Re: Comments on the Phoenix AMA Fourth Management Plan Draft

Salt River Project Comments on Fourth Management Plan
8/2/2019

Phoenix AMA Overdraft Rolling Average, 1985 to 2017

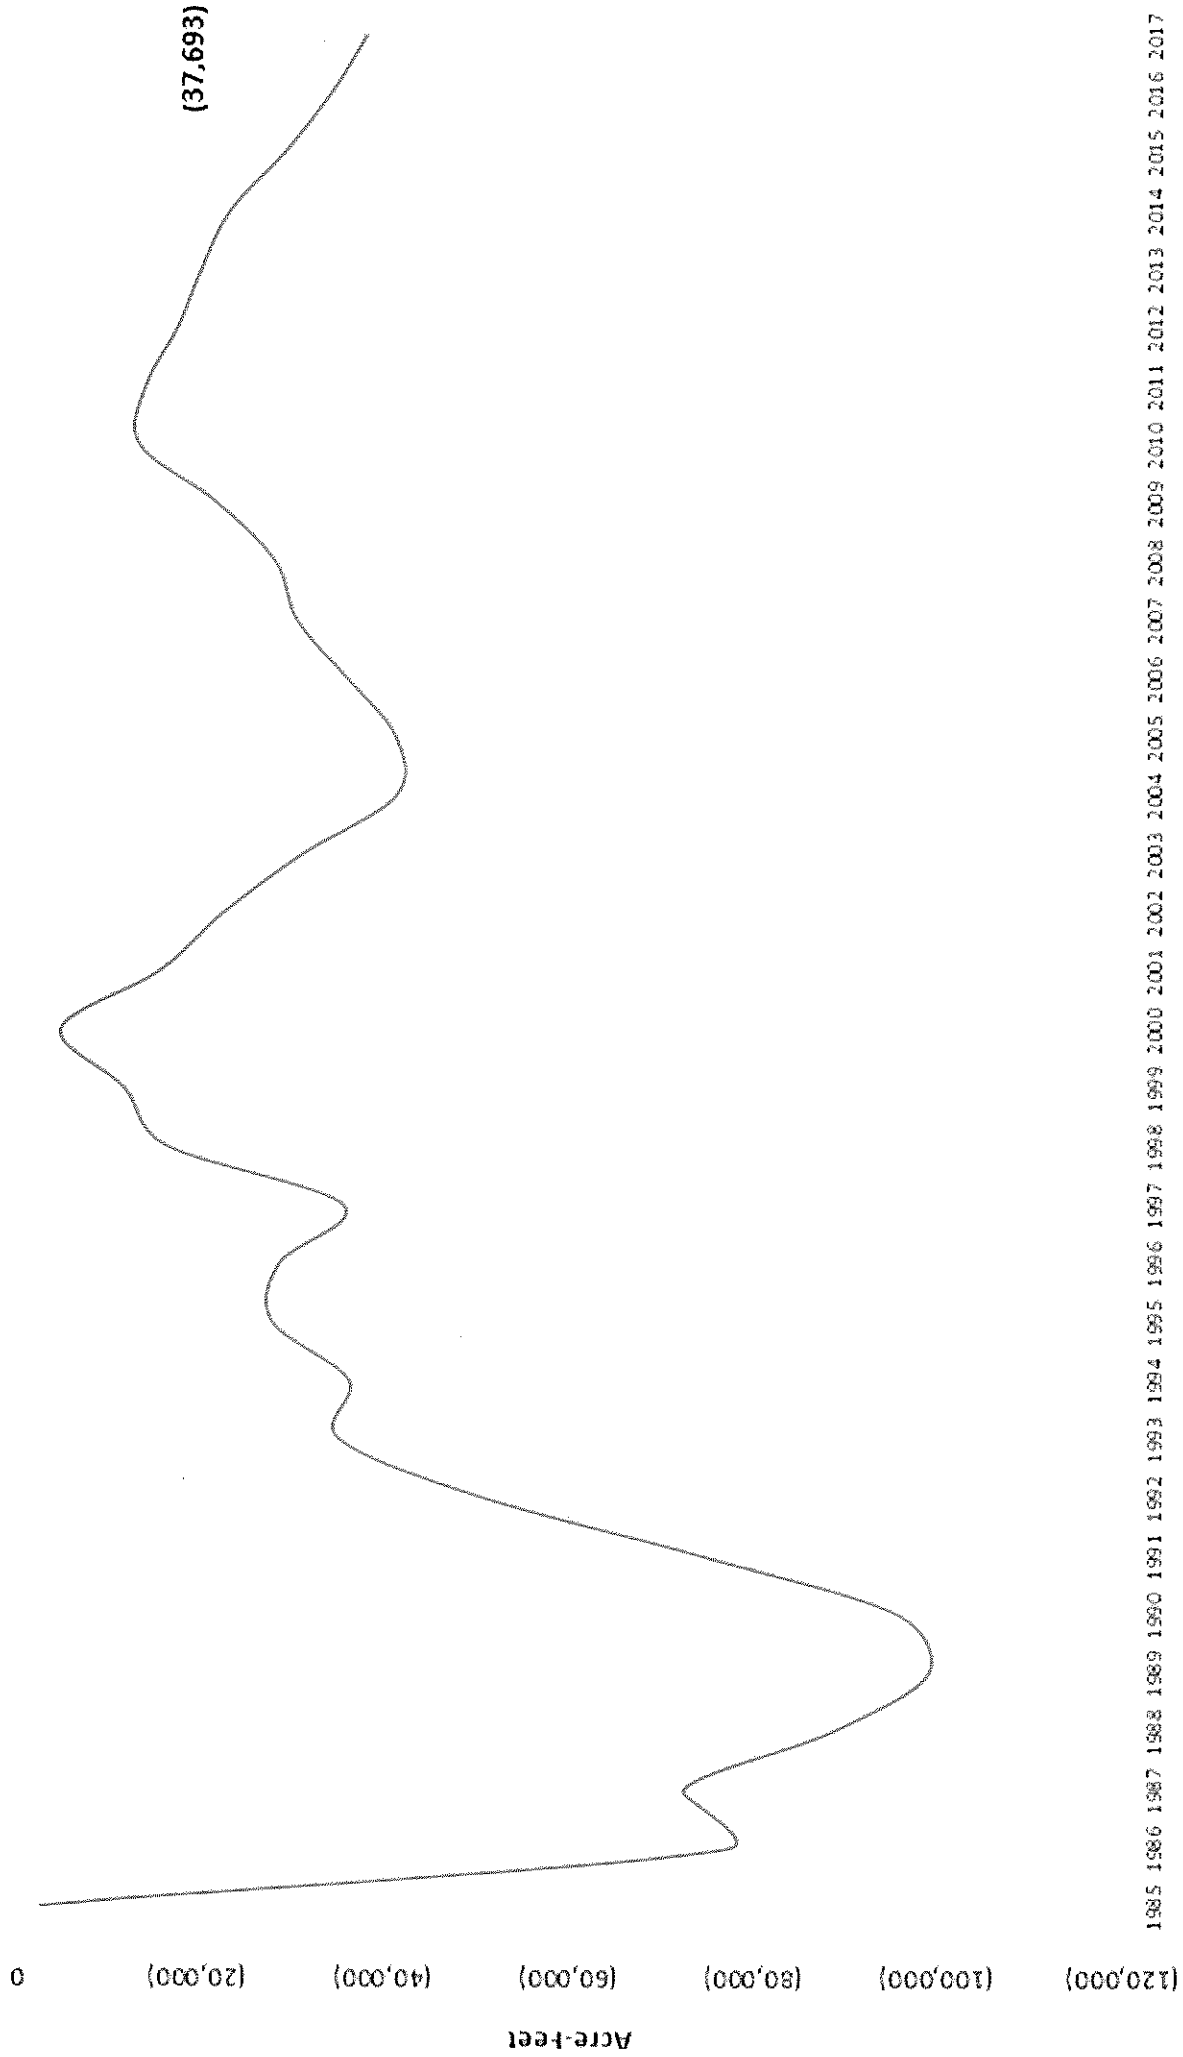
As we approach 2025, one of the major issues raised by the draft plan is how best to refine the safe-yield definition. As noted in the plan, the goal of the Phoenix AMA is to achieve and maintain

a “long-term balance” between the annual amount of groundwater withdrawals and natural and artificial recharge in an active management area. How exactly to define “long-term” and how to incorporate it into the assessment of safe-yield is an open question. We suggest that ADWR consider measuring safe yield across the historic period of natural variability in surface water supplies available to the Phoenix AMA, which we know from the historical records kept by SRP and tree ring research conducted by the University of Arizona for the Salt River and Verde River watershed approaches 50 to 60 years.

The benefit of a long-term average approach is that it captures the natural variability in available surface water supplies and its effect on groundwater use and natural recharge, and more accurately shows the long-term impact of both wet and dry cycles. Using a shorter period than the natural variability of surface water supplies could give a false assessment of safe-yield, depending on whether the shorter period is during a wet or dry cycle. SRP is keenly interested in this topic and would welcome the opportunity to work with ADWR and other stakeholders on developing an approach for assessing the AMA’s progress towards a long-term, safe-yield balance.
